**TO:** Ryanne Sass, Plaza Street Partners  
**FROM:** Stacey Nerger, Senior Planner  
**DATE:** October 11, 2022  
**SUBJECT:** Lincoln Professional Park – Preliminary Site Plan  
Review Comments 05

# LINCOLN PROFESSIONAL PARK FILING NO.1 PRELIMINARY SITE PLAN

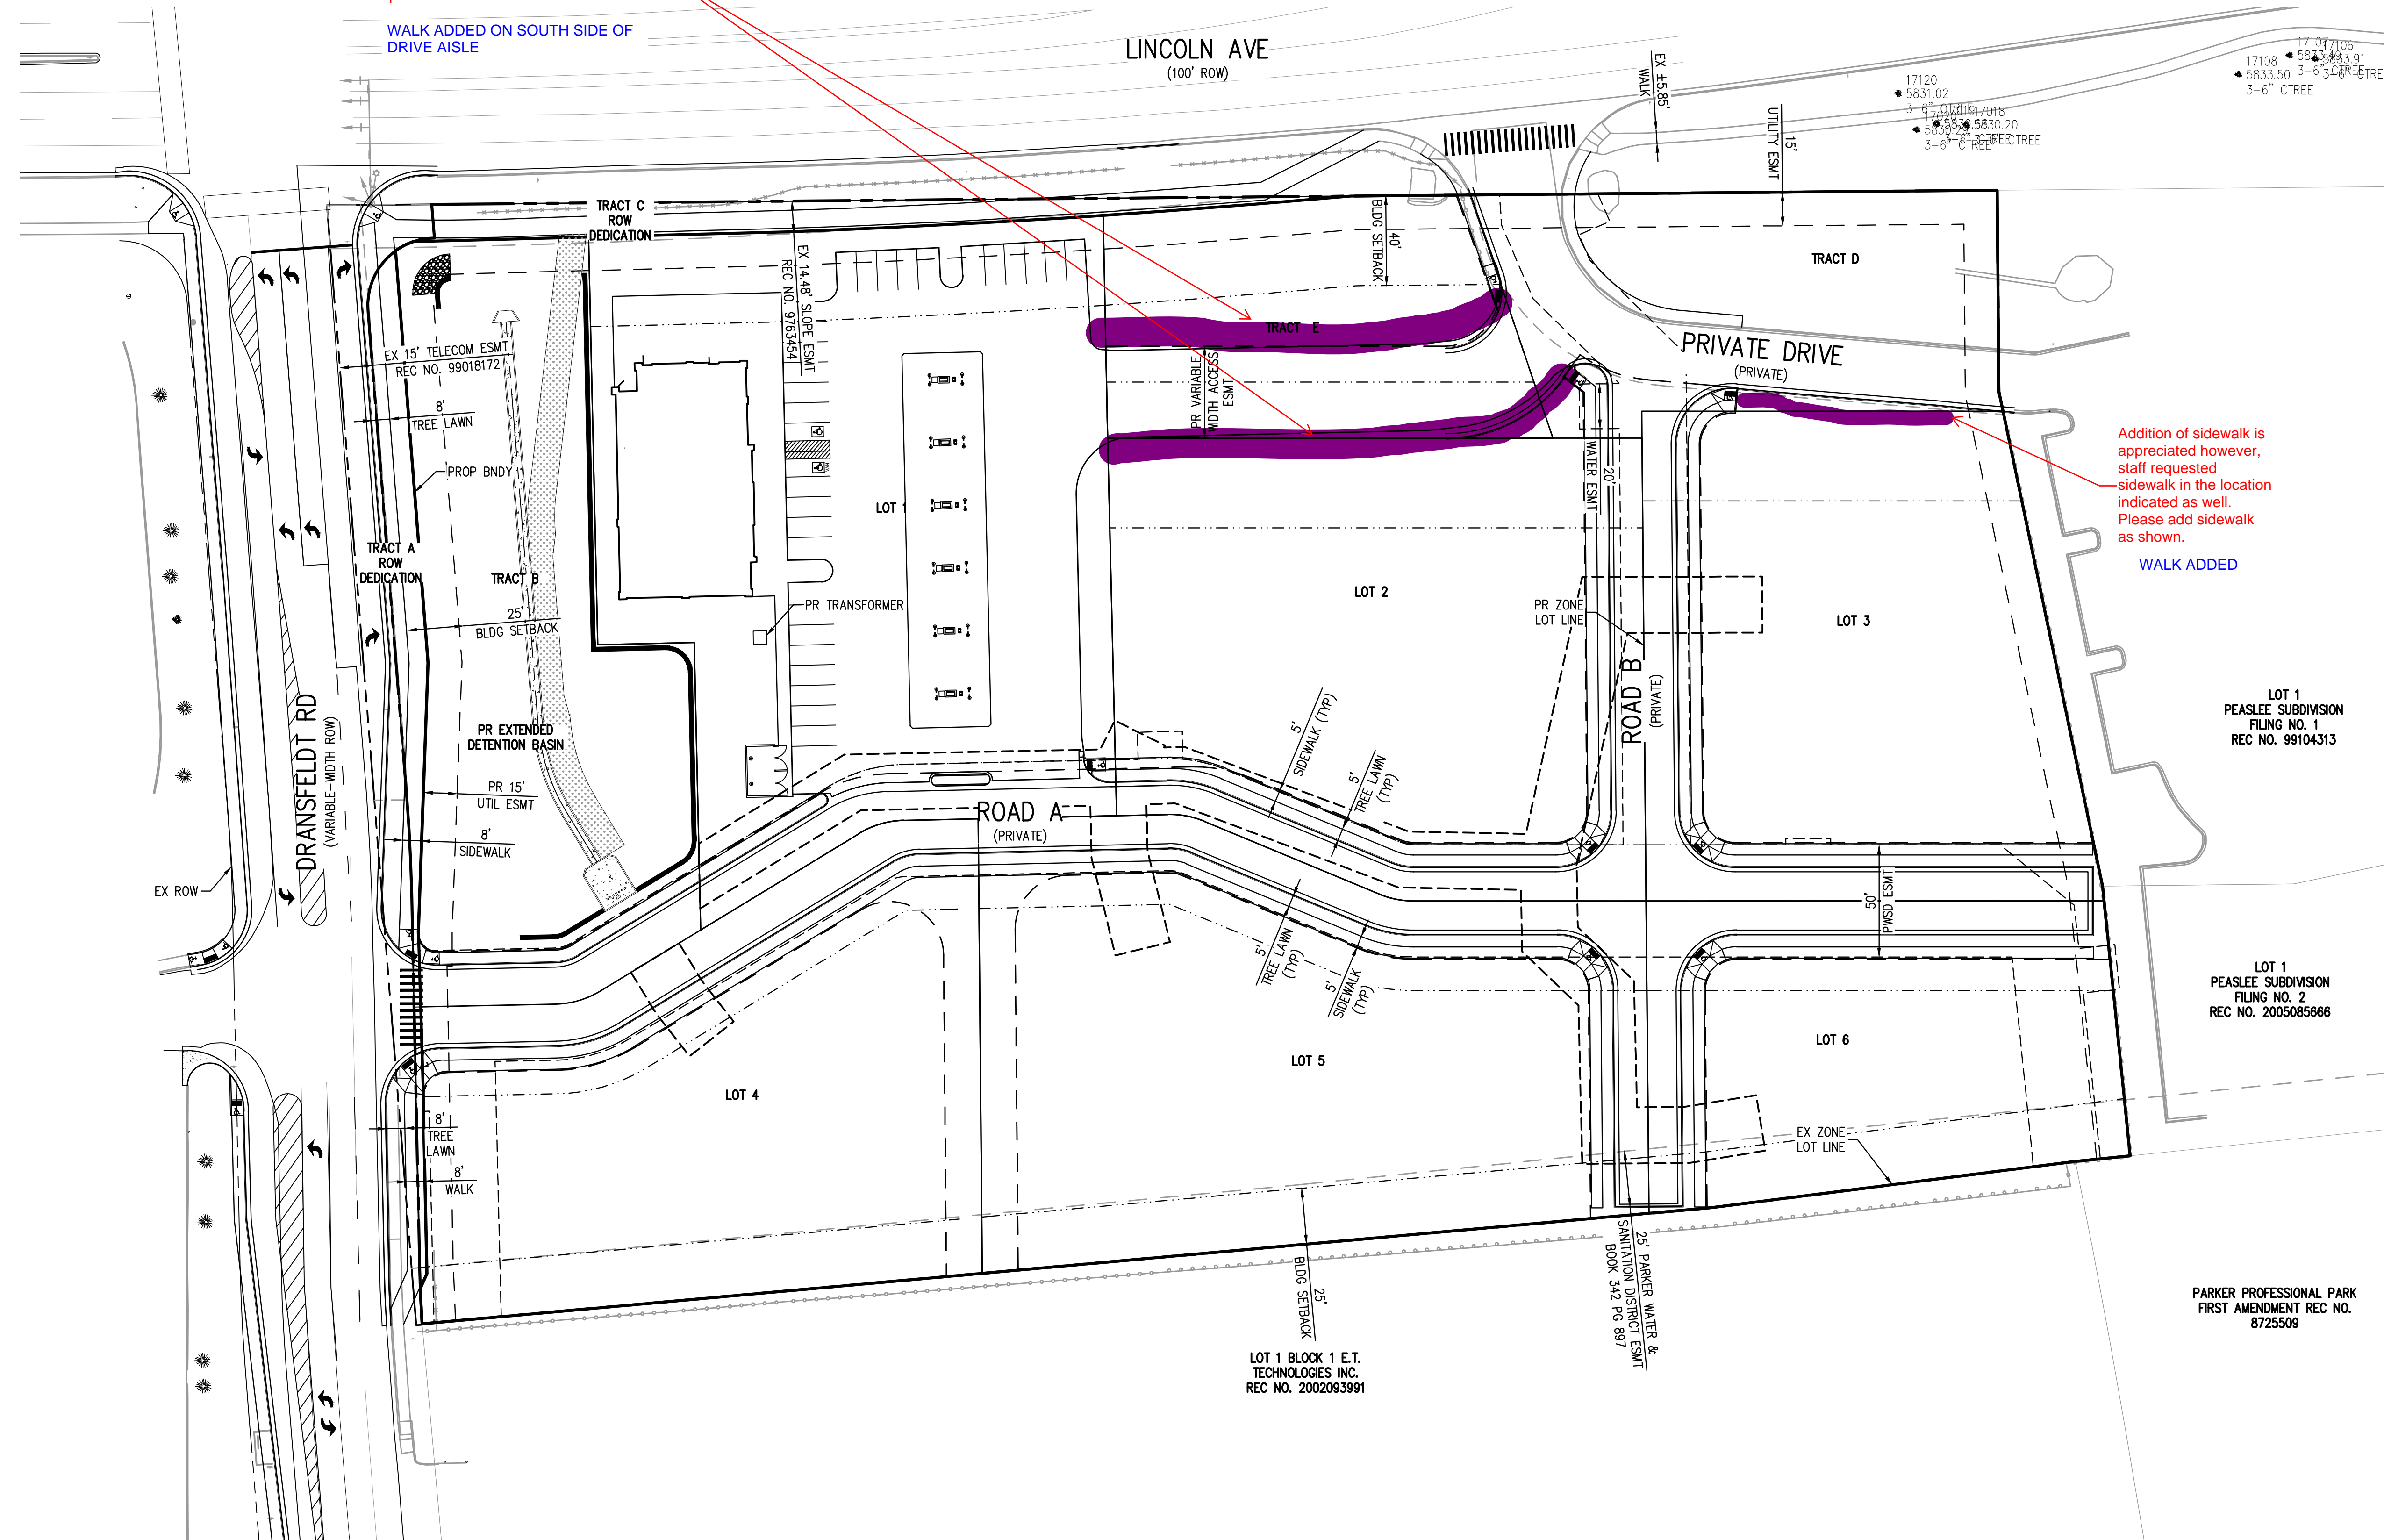
Sorry for missing this in the previous review. But please add a sidewalk to at least one side of this internal road. It may be easier to provide within Tract E.

Addition of sidewalk is appreciated however, staff requested sidewalk in the location indicated as well. Please add sidewalk as shown.

WALK ADDED ON SOUTH SIDE OF DRIVE AISLE

WALK ADDED

REVISION DATE: ISSUE DATE: 09-22-2022 LANDSCAPE PLAN SHEET 3 OF 5

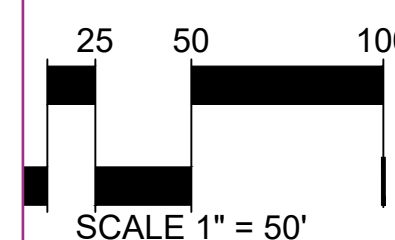
Addition of sidewalk is appreciated however, staff requested sidewalk in the location indicated as well. Please add sidewalk as shown.

Due to utility conflicts shrubs were added instead. Please include a column for the number of shrubs provided. Based on the Town LDO, 10 shrubs can equal 1 tree.

Staff comment indicates these calcs should remain the same. They have increased. The response from the applicant indicates that the radii (only) have been omitted from the calculation. Staff believes these numbers should have decreased? Please clarify. Additionally, these numbers affect the minimum street tree requirement, please verify that these changes remain in compliance with street tree requirements. Verification needs to appear in writing.

As discussed with the applicant, since this tract is not buildable. Landscaping will need to be provided at the time of MDP. The entire tract shall be landscaped. Please include a minimum of 1 tree and 5 shrubs per 1,500 sq. ft. of landscaped area. Trees and shrubs can be grouped.

Add street trees along the side of the internal road where the new sidewalk is added. Assuming it will be on the north.

Noted, tract landscaping has been provided in separate MDP application plans.

Sidewalk and street trees have been provided in noted location.

Table has been provided documenting shrub/grass substitutions.

Calculations have been rerun and verified as those listed in revised plans. A document breaking down various calculations and associated requirements has been provided.

Street trees have been provided for added sidewalk at south side of drive
